The Following information is based on PCB type M12565 iss.3 The layout can be applied to other versions but the instructions below may not relate.

Revision: 1	d.c. ~ daylight ltd.	Page Size: A4	d.c. ~ daylight ltd.
QUAD 405 new non-inverting input			5 Greenacre Drive Pontprennau Cardiff CF23 8PA
8 February 2004	Drawn: K. Snook	Checked:	Tel: +44 29 20 657149 Fax: +44 29 20 657151
		Page 1 of 1

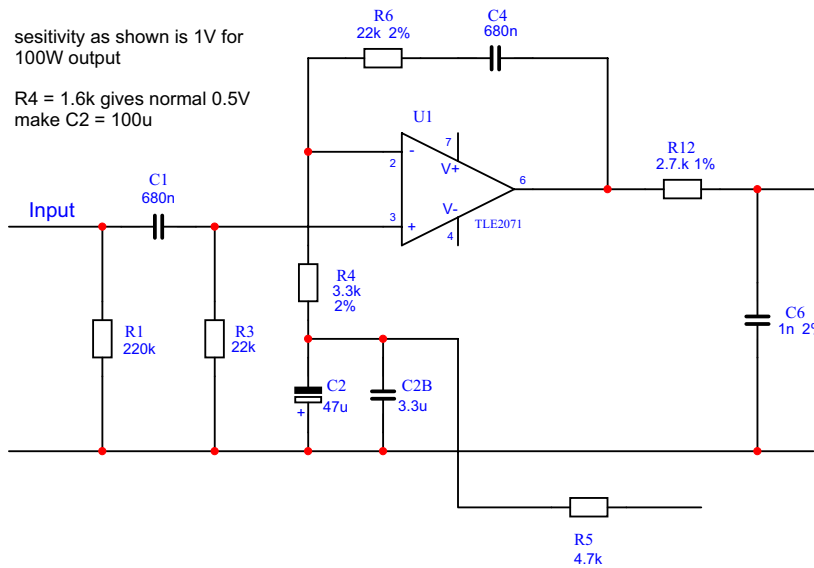
Cut track to op-amp pin 3 close to pin, remove link pins and zener diodes D8 and D9.

Replace R10 with wire link, fit new values for R4, R6 and C4.

Fit new R3 standing upright such that it bridges R4 and fits between end of C1 and the hole to ground where the link pin was.

Fit wire link from op-amp pin 3 to junction C1/R3 this can follow a path against a ground track.

Changing R12 to 2.7k increases the frequency response to about 59kHz, this may not be suitable where the dumpers are "slowed down" in other versions of the design.
